AFFIDAVIT

I, Charles C. Stokes, am providing this statement of my own volition in response to various Pacific Gas and Electric (PG&E) submittals to the NRC. This is intended to follow up on issues which I have raised in prior statements to the Commission and which I feel must still be addressed in detail by PG&E Diablo Project management before Unit 1 is allowed to go beyond 5% power. In some cases my comments suggest necessary methodological steps to obtain adequate correction action on my allegations, largely confirmed by Mr. Yin. In other cases, my comments expose false or misleading statements by PG&E in their response to Mr. Yin's inspection report.

In response to PG&E letters on the subject of **Tube Steel Radius and Flare-Bevel Welds** as addressed in the April 7, 1984 and April 11, 1984 to the members of the Appeal Board, and PG&E letter No.: DCL-84-083, DCL-84-164, DCL-84-166, and DCL-84-190.

ATTACHMENT 1

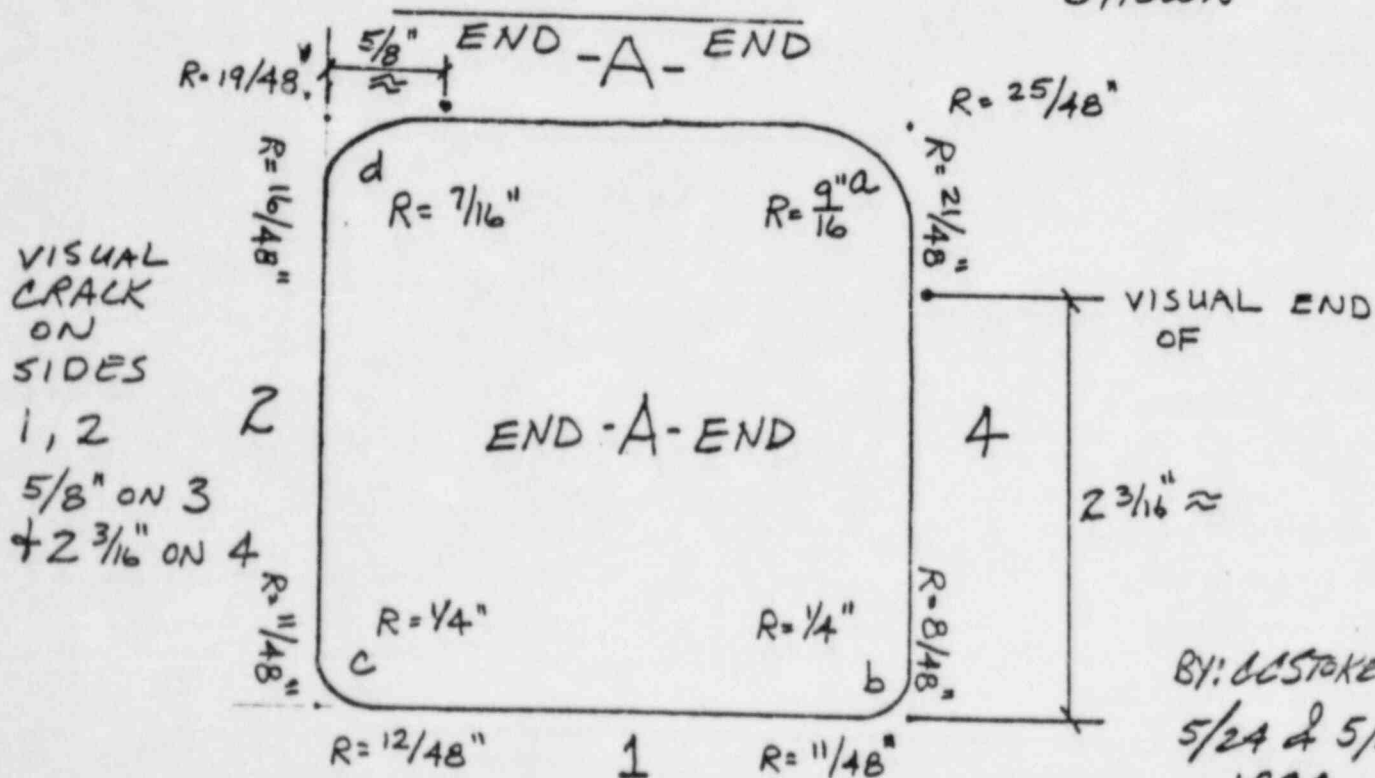
This tubing (Attachment 1 sketches) not only has a corner radius less than 2t but has only one (1) corner which is 2t. Three corners are less than 2t, of which two (2) are only 1t as I and others have confirmed. It measures 1t using the Straight Ruler Method (per PG&E) and using the Concave Radius Gage Method. An additional flaw exists, which before seeing this piece, not even I was aware of. The tube wall has what appears to me to be a lamination crack running all the way around its' perimeter. This lamination crack is almost exactly at the center line of the tube wall.

VISUAL
CRACK
ON
SIDES
1, 4
AND 2 3/4" ON 2
ENDS IN
RADIUS 3 to 4

ATTACHMENT 2, a

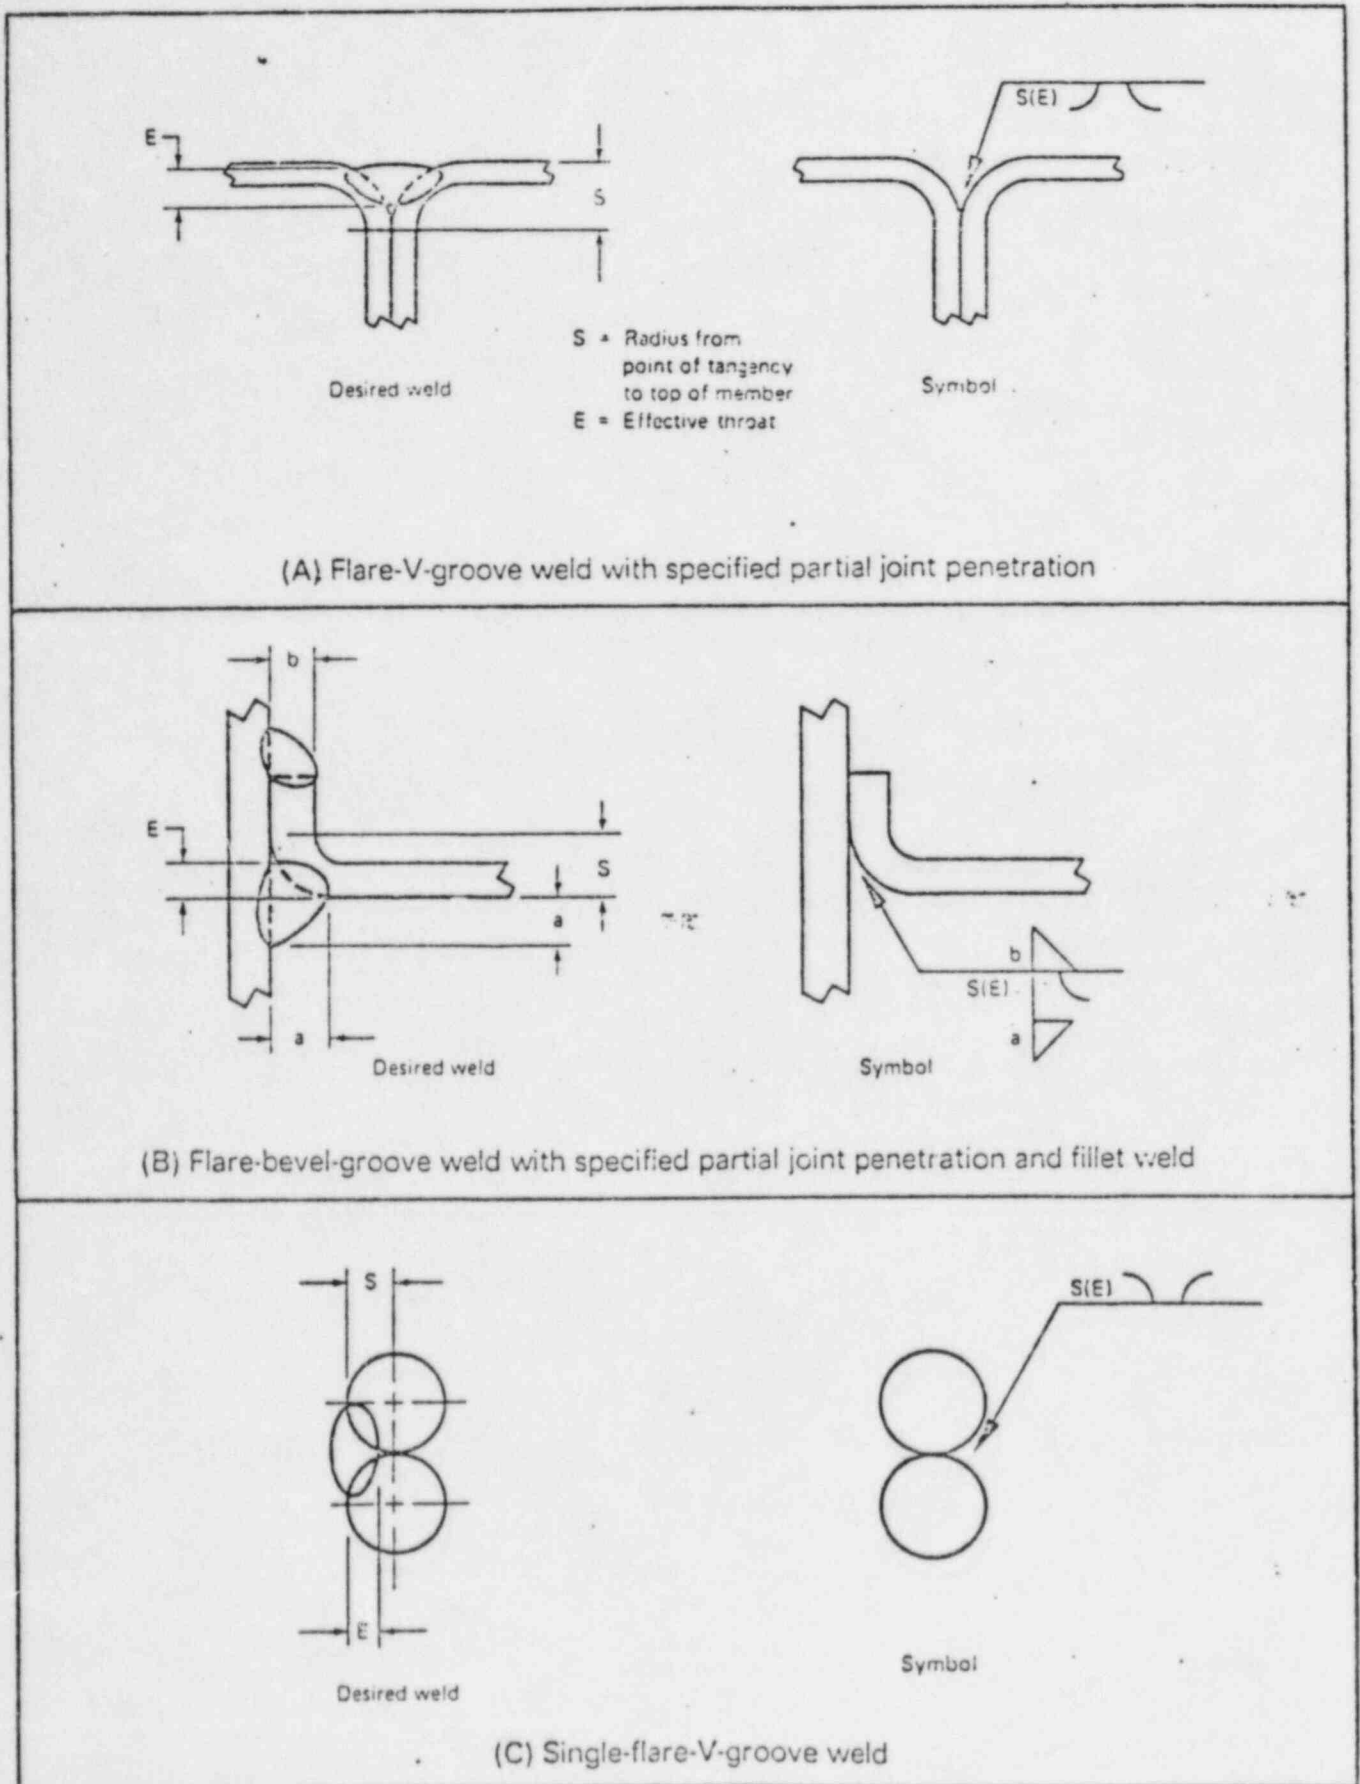
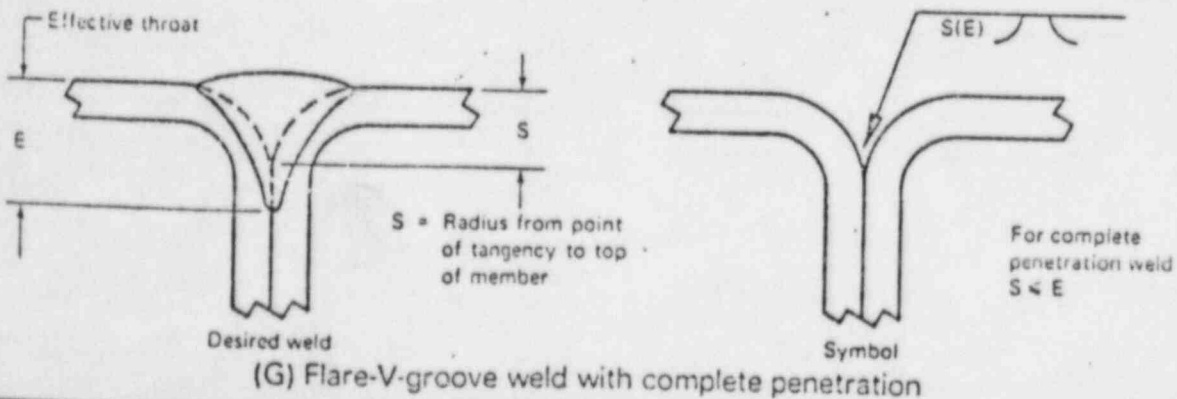
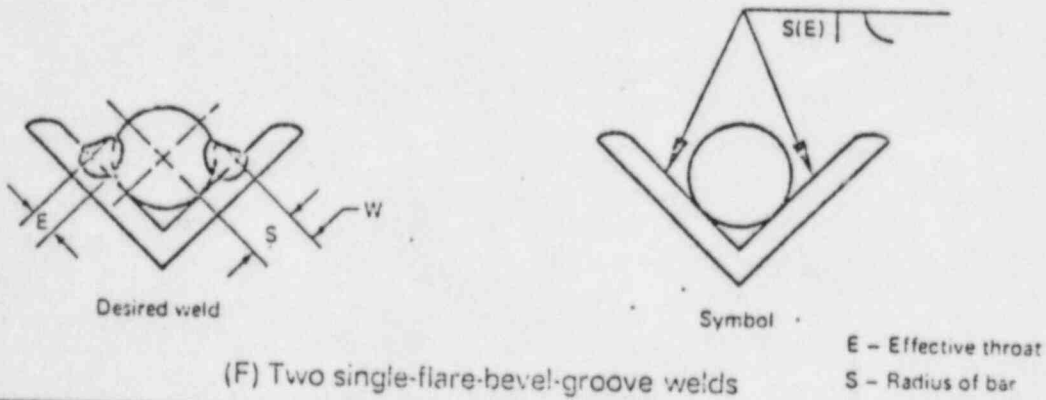
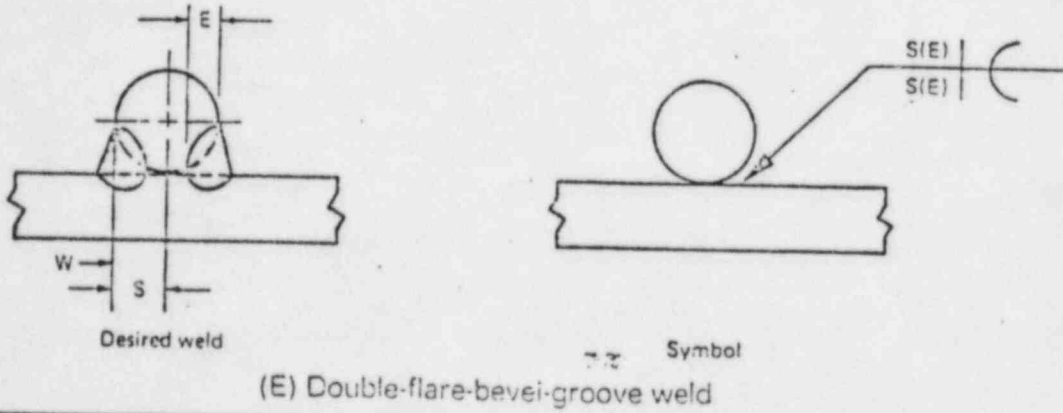
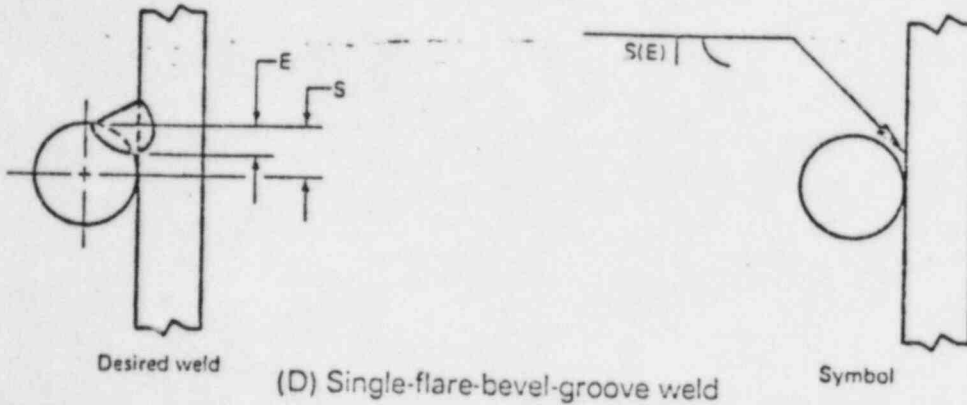
As an engineer and in accordance with the established guidelines of relevant professional CODES, I feel the above data should be factored into the methodology. In the case of pipe support steel design, I will and would like to see applied at Diablo Canyon the definition of tube steel radius as defined by either the (AISC) or the (AWS) CODES. Based on my knowledge, and after review of pages 4-131 to 4-149 and Section 1.17 "WELDS" on page 5-44 of the AISC manual, I decided that the answer must be within the AWS document. Both documents govern the construction of pipe support steel, but on page 4-149 and 5-44 the AISC references the reader to the AWS code for this issue.

LOAD CASE DETERMINATION PER M-9

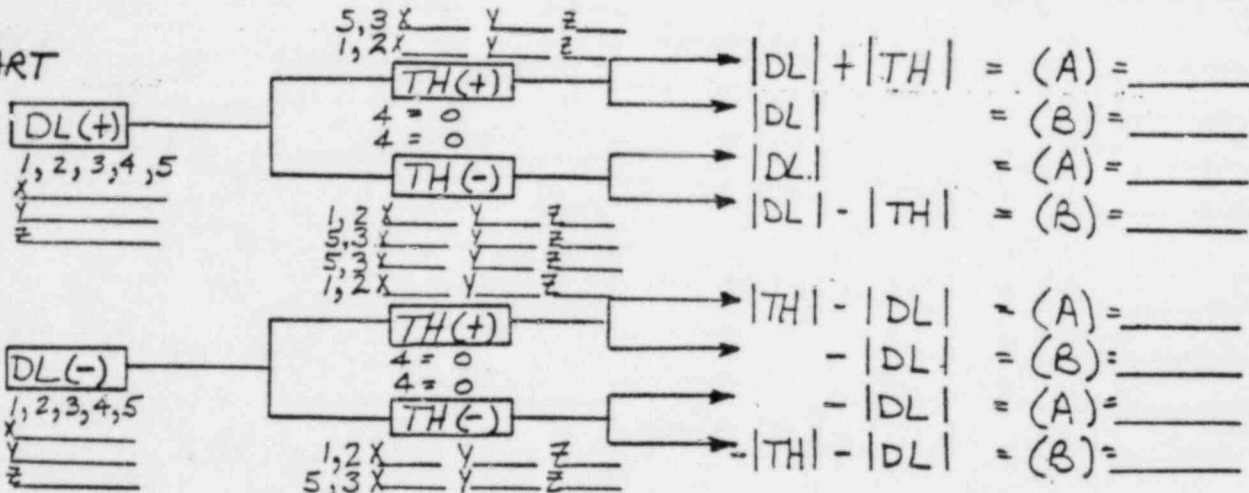
I have added what I believe to be clarification letters to this form which were not part of the original, or were used by only a few other engineers. I added the (A) or (B) letters to the load cases on form 3a. Though it may not be obvious the difference between 1A and 1B, 2A and 2B, etc. is quite simple. All cases with an (A) are the most positive value that can be determined using the formulas and notes on the bottom of the form and all cases with a (B) are the most negative values, also based on the formulas and notes on the bottom of the form. Most of the time I only used this form for the most simple support, i.e. one (1) pipe, 2 directional restraint. For this type support and using this form, four (4) combinations are possible for Load case 1, not just the two (2) which are on the sheet by the 1A or 1B, but also the diagonal cases.

Forms 3b and 3c have been included in Attachment 3 along with a discussion of their development. They are intended to be used as an example of the kinds of detail which should be included in any procedures on load determination, as well as examples of changes to the forms which should be made so that all engineers are consistent in the load calculations. The types of supports addressed in this
